NUMBER: 83-17

- A. Oil Leaks on MCM 120R/140R Engines
- B. Transmission Fluid Venting Out of Tube - Borg-Warner Transmissions

Figure 1. Flywheel Housing

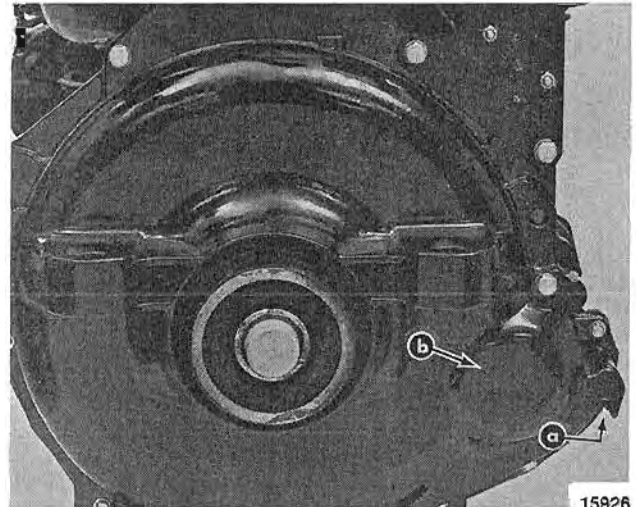
We have received complaints about oil in the sealed flywheel housing on new MCM 120R/140R engines. When the engine is started, during the predelivery check, oil sprays out of the "water pump out vent". This vent is located on the starter motor side of the flywheel housing.

This could be "normal" with the new, sealed flywheel housing under certain conditions. If the boat is shipped at an angle (bow high) from the O.E.M., oil may leak from the rear main crankshaft seal (Part No. 26-58203). This seal is not a static oil seal. The crankshaft has to be turning before the seal is "oil tight". This leaking oil, on 1982 and older engines, ran into the flywheel housing and then into the bilge of the boat. In the past, oil in the bilge was thought to have come from the power trim system during its installation, when in fact, it came from the rear main crankshaft seal. It is suggested that the engine be run until the oil stops spraying out of the vent hole. At that time, the oil can be wiped up. Do not confuse this type of oil leak with the following leaks.

Figure 2. Removing Charge Tube

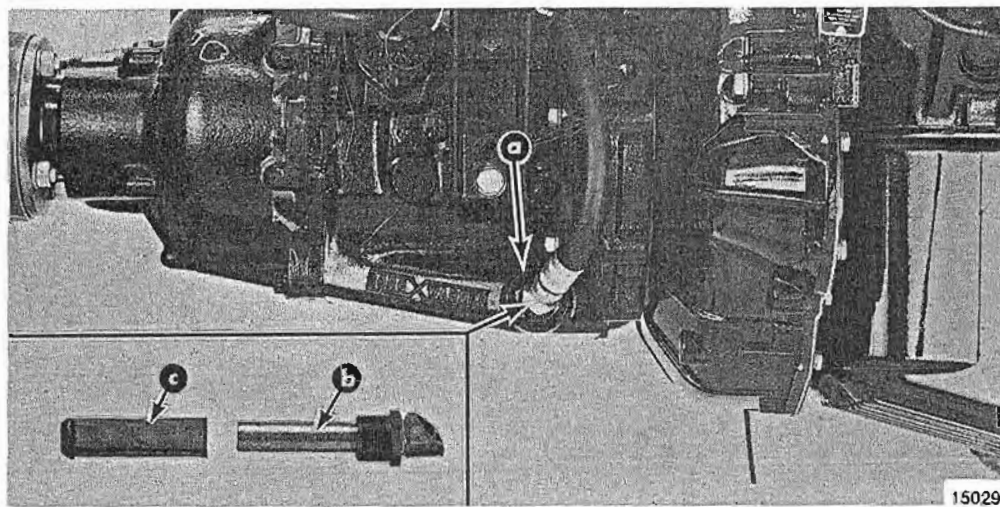
Under certain operating conditions such as, but not limited to; constant high RPM operation or high engine angle (while underway), can cause the transmission to vent fluid out of the vent tube. To help correct this condition, determine the model and gear ratio of the transmission that is having the venting problem. Refer to chart below and perform modifications as shown below.

a - Remove Cooler Return Hose Bushing from Transmission c - Reinstall Strainer and Bushing and Refill Transmission
 b - Unscrew Charge Tube from Bushing and Discard Tube
